80286 (C-2) Information Package
21 November 1984

This applies to S-spec #40172 and to S-spec #54036 of the 80286, marked as

Errata Items:

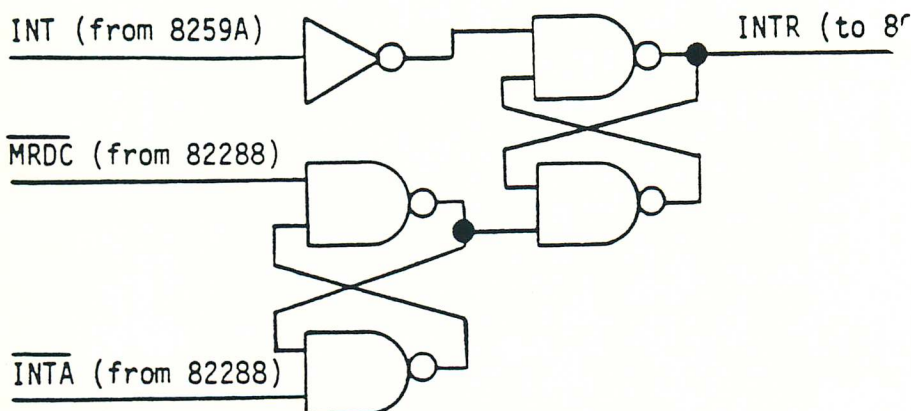
1. **DON'T REMOVE INTERRUPT SIGNAL EARLY**
When the INTR is activated and external interrupts are enabled, INTR must be held active until the CPU begins performing the first INTA bus cycle to process the interrupt, or else unpredictable CPU behavior could result. See additional information page 6.

When the INTR is activated and external interrupts are enabled, INTR must be held active until the CPU performs the first INTA bus cycle to process the external interrupt. Failure to keep the INTR active until the first INTA cycle occurs could cause unpredictable CPU behavior. When this errata is corrected, failure to keep the INTR input active will only possibly prevent the external interrupt from being recognized.

When using the 8259A Priority Interrupt controller, below are several cases in which an active 8259A INT output will go inactive, possibly before the 80286 CPU generates its first INTA cycle to process the interrupt. Both cases below can be handled if the 80286 interrupts are always disabled before programming the interrupt controller.

Alternatively, below is a circuit which handles any interrupt removal problems without any software changes. The circuit below latches the 8259A INT output before it is sent to the 80286 INTR input. The latch becomes transparent between the first INTA pulse and the first read of the vector from the interrupt vector table.

The default interrupt function of the 8259A will guarantee a proper vector for IR7, the default interrupt, if at the time INTA is performed no unmasked interrupt is active. The interrupt handler for IR7 can read ISR7 of the 8259A to tell if this was a real interrupt on IR7. The ISR7 bit will be 0 if at the time the interrupt was acknowledged, no unmasked IR inputs of the 8259A were active ("phantom" interrupt).
